Re: Site Plan Application – Design Brief  
3700 Twin Falls

## Urban Design Brief

East Elevation

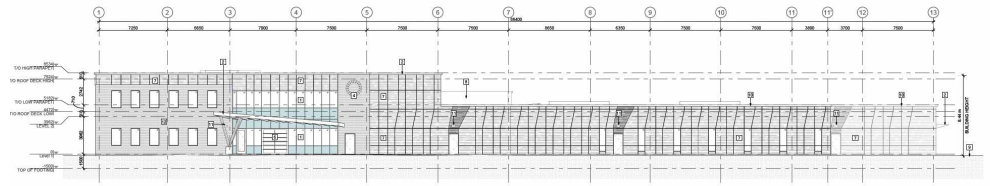
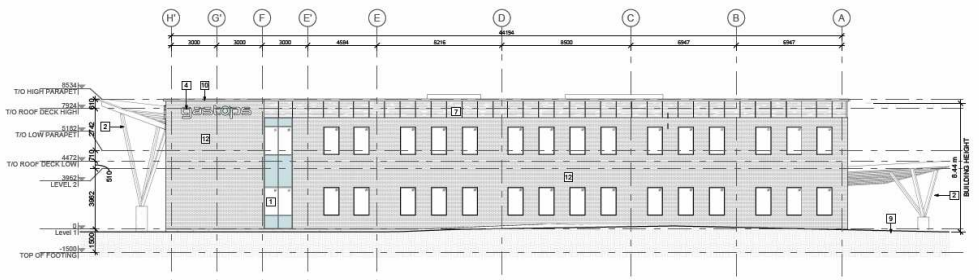
12. For the façade facing Limebank, please include windows when possible. Where blank facades cannot be avoided, utilize landscape elements to break up the building wall.

*CSV Response: The area along Limebank encompasses an outdoor staff amenity area. Landscaping will be increased in this area, in addition the design includes for maximum amount of windows without comprising security of the building into the manufacturing areas.*
